SUBJECT: CYCLE 11 RELOAD (TAC NO. 67467)

Re: Dresden Nuclear Power Station, Unit No. 3

The Commission has issued the enclosed Amendment No. 94 to Facility Operating License No. DPR-25 for Dresden Unit 3. This amendment is in response to your application dated March 9, 1988 as supplemented by your June 17, 1988 submittal.

The amendment changes the Technical Specifications to support Cycle 11 operation of Dresden Unit 3 with Advanced Nuclear Fuels Company 9x9 reload fuel, and Section 3.E Restrictions, of the license.

Figure 3.5-1A

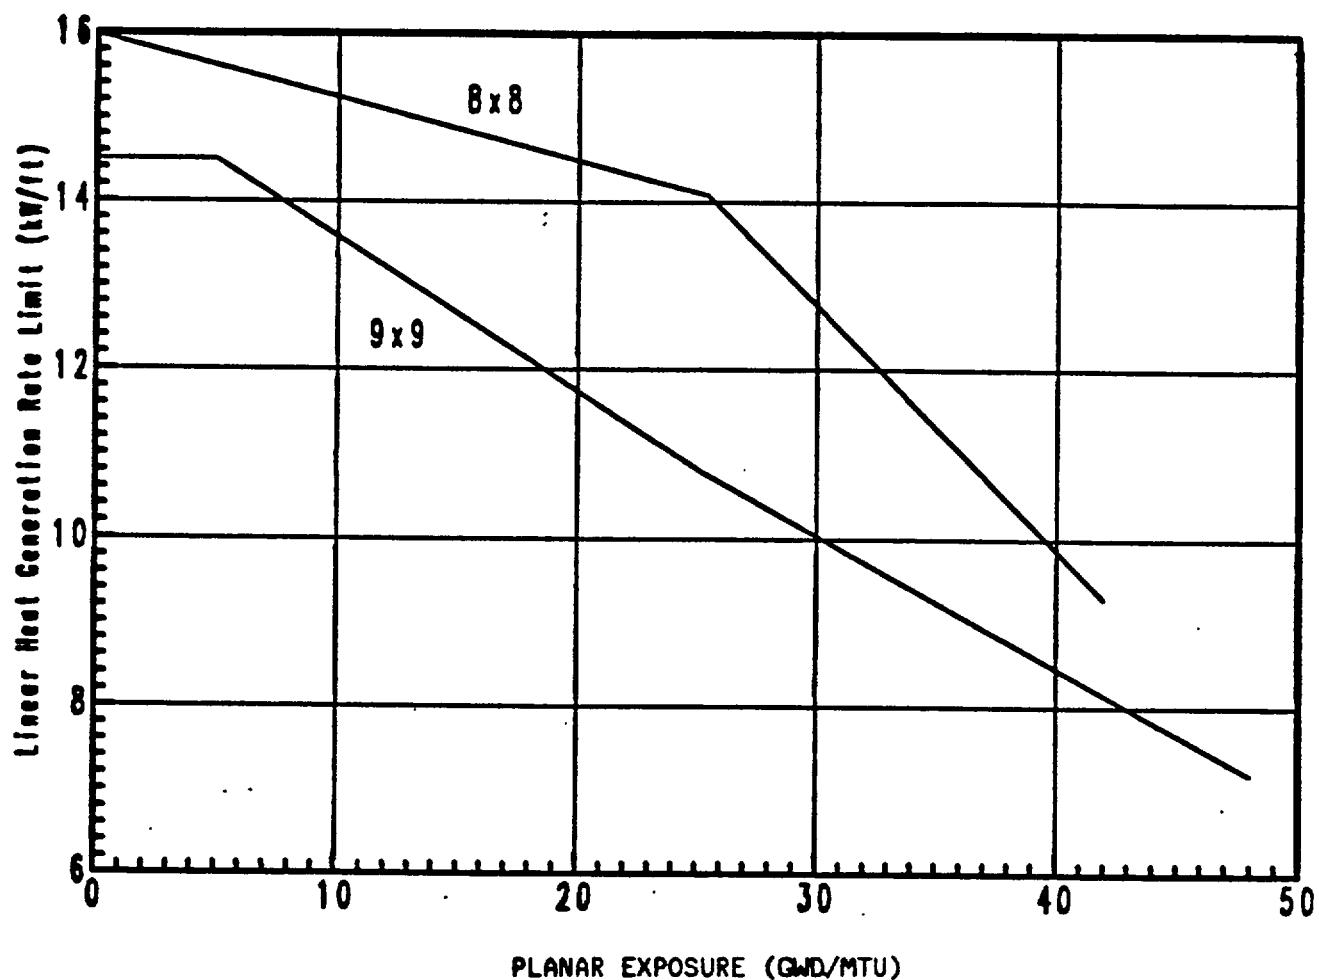
- (8) Specification 3.5.J, 4.5.J: The Section 3.5.J title is changed to "LOCAL STEADY STATE LHGR," references to FDLRX are added, GE LHGR design value of 13.4 KW/ft is deleted from Figure 3.5-1A, and "STEADY STATE" is added to title. These administrative changes are acceptable.

<u>8x8 Fuel</u>		<u>9x9 Fuel</u>	
Exposure	LHGR	Exposure	LHGR
0.00	16.00	0.00	14.50
25.40	14.10	5.00	14.50
42.00	9.30	25.20	10.80
		48.00	7.20

Figure 3.5-1B

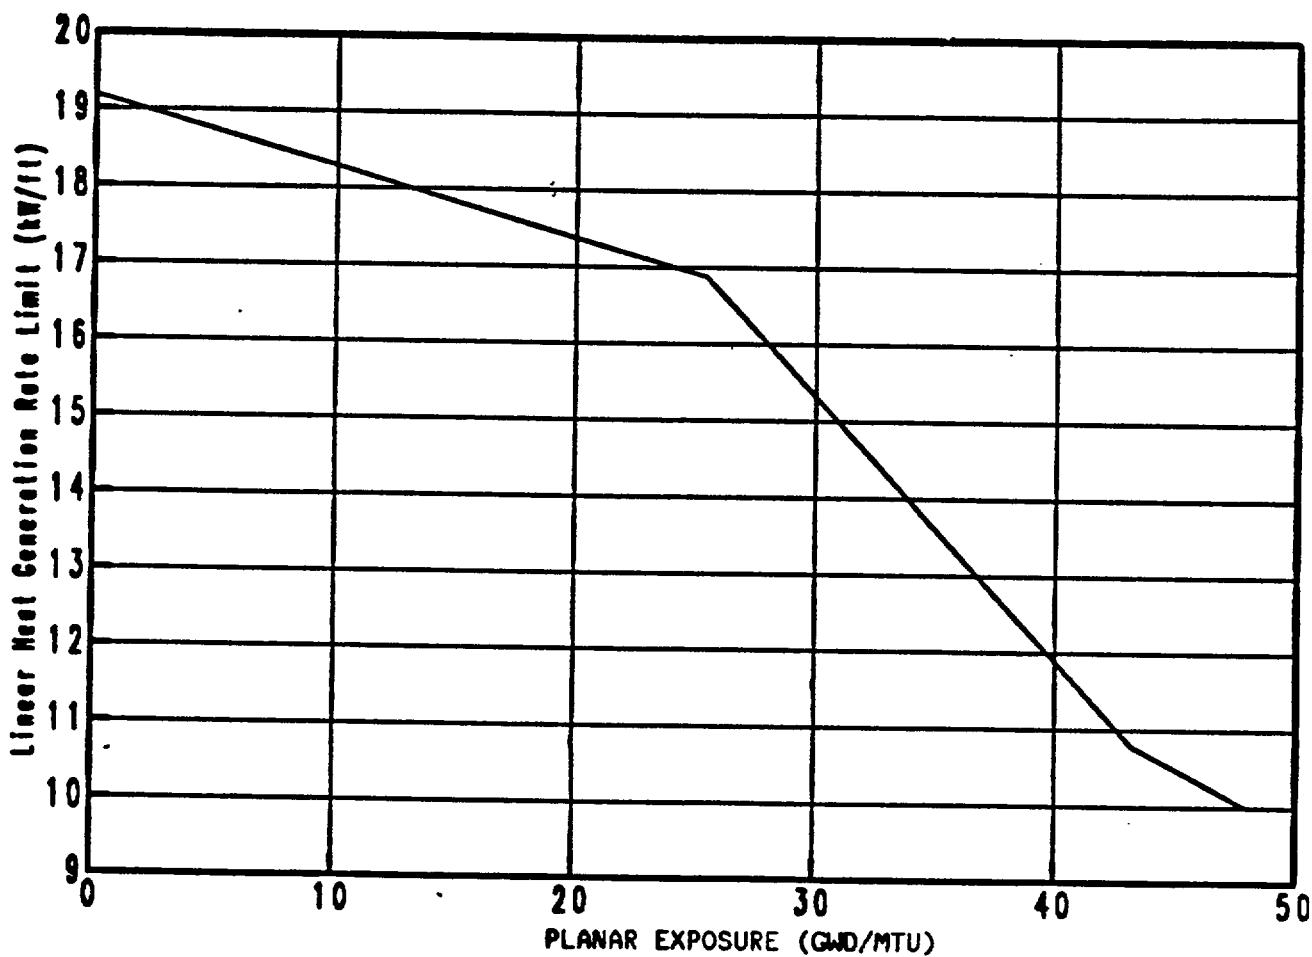
- (9) Specification 3.K.5: A new Section on local transient LHGR and FDLRC is added as well as Figure 3.5-1B showing the Transient LHGR Limit curve. These administrative changes are acceptable.

Figure 3.5-2 (Sheet 1 of 3)  
MCPR Limit for reduced Total Core Flow

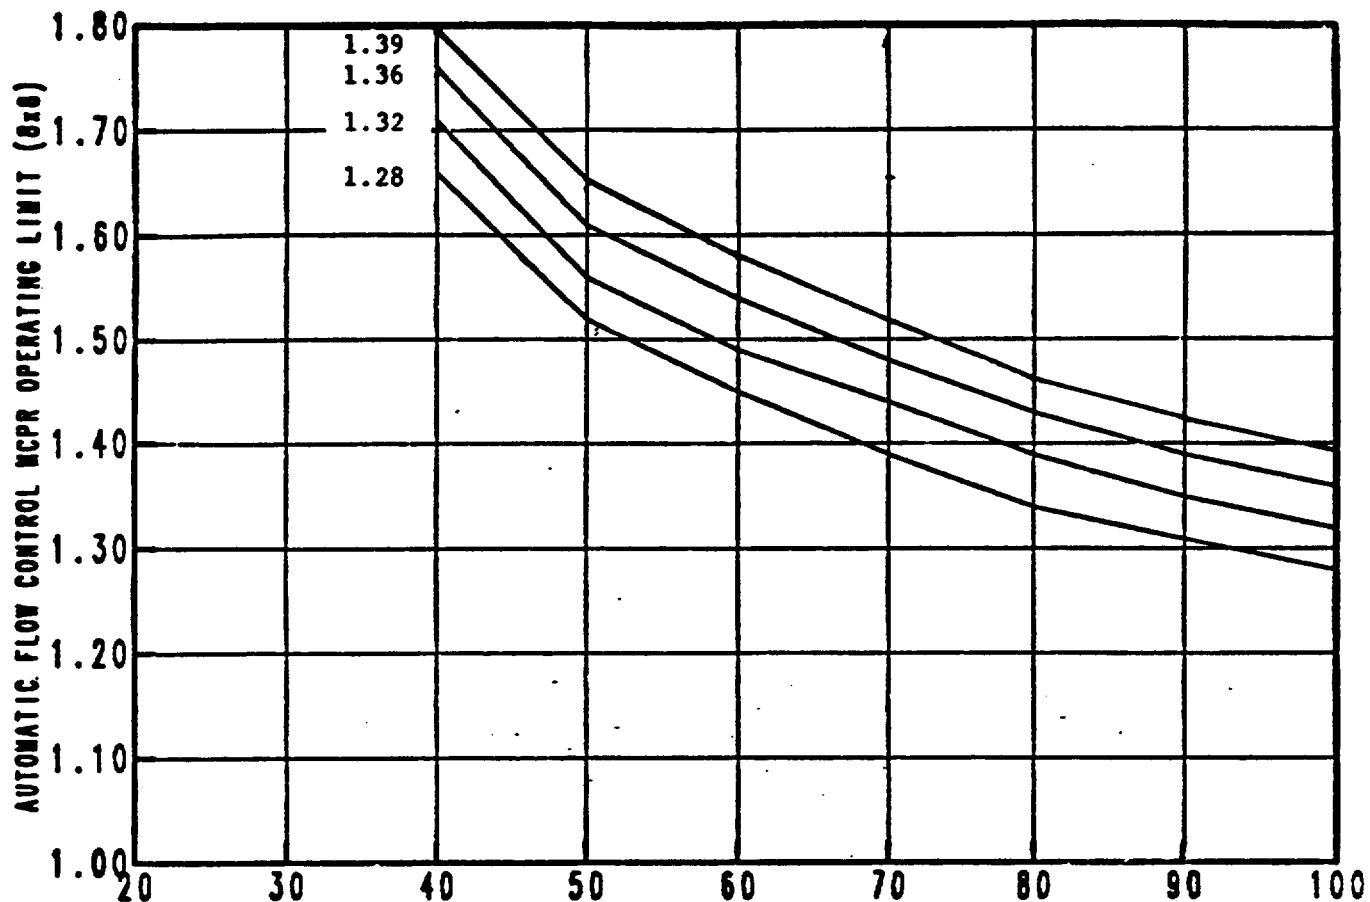
- (4) Specification 3.5.L.1 and Figure 3.5-2: The Figure (Sheets 1, 2, and 3) is revised to incorporate changes in reduced flow MCPR values. This has been evaluated in Section 2.5 and found to be acceptable.

Total Core Flow (% Rated)	MCPR Limit	
	8x8	9x9
100	1.10	1.09
90	1.15	1.14
80	1.21	1.20
70	1.28	1.26
60	1.36	1.34
50	1.46	1.44
40	1.60	1.57
